RESPONSE TO LRD OPINION

In respect of a Proposed Large Scale Residential Development
on Lands at Ardshanavooly, Killarney, Co. Kerry

CLIENT: Wrightwood Development Ltd

**Re: Planning and Development Act, 2000 (as amended) – Section 32D, Large Scale Residential Development Opinion.
Proposed Large-Scale Residential Development (LRD) at Ardshanavooly, Killarney comprising 124 dwelling units and site development works.**

Extract DMURS – shows hammer head vehicular turn in Cul-de-Sac.

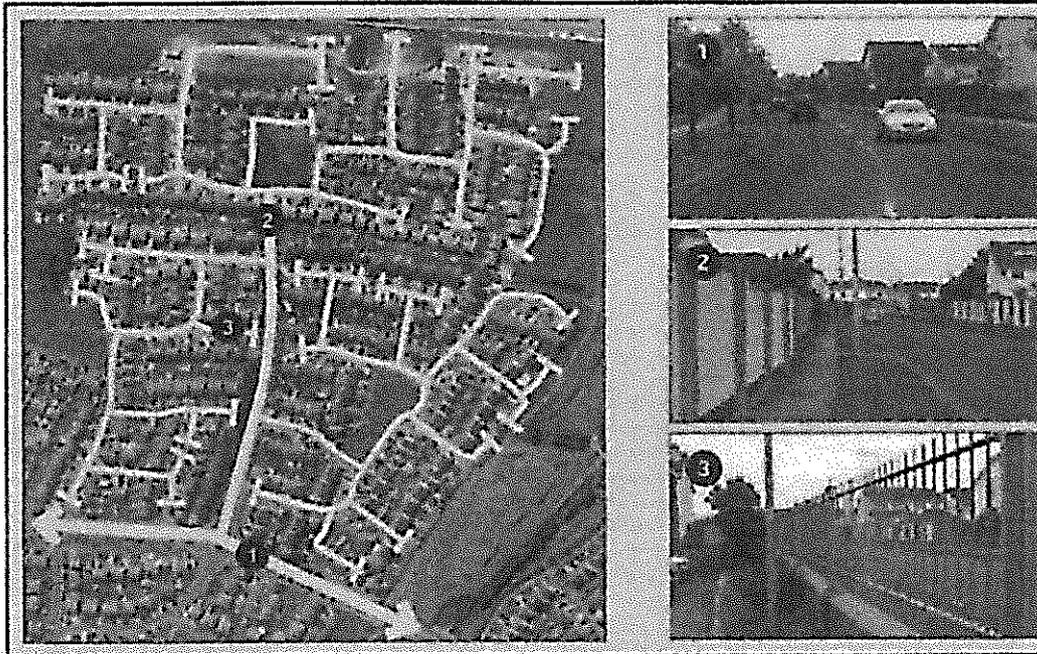
MHL – DMURS document – local street - is silent on > 50 metre dead end cul-de-sac – no provision for bin lorry, fire vehicle or commercial vehicle etc to turn. So will reverse unsighted.

DMURS does not deal/assess regards dead ends / cul de sac. Site Development document is still in use and not superseded.

- 3.17 Refer to Autotrack Drawings issued as part of the application.

FIGURE 2.2: RESIDENTIAL TURNING BAYS

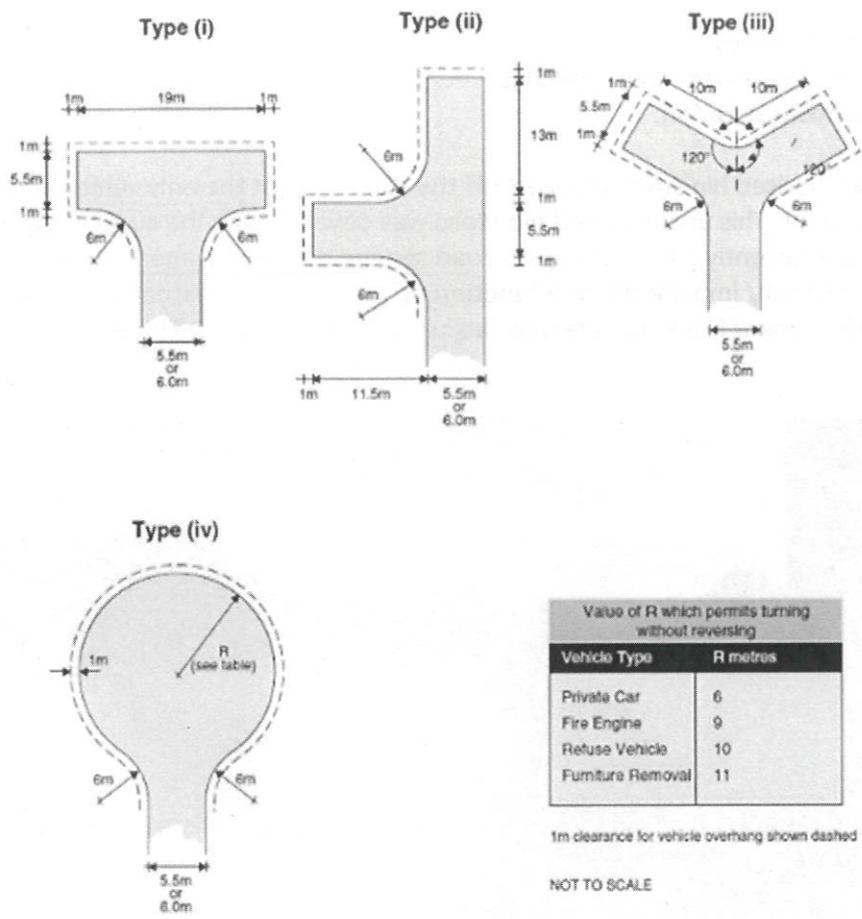
Consider turning circle – hammer head or similar.

3.55 Refer to Autotrack Drawings issued as part of the application.
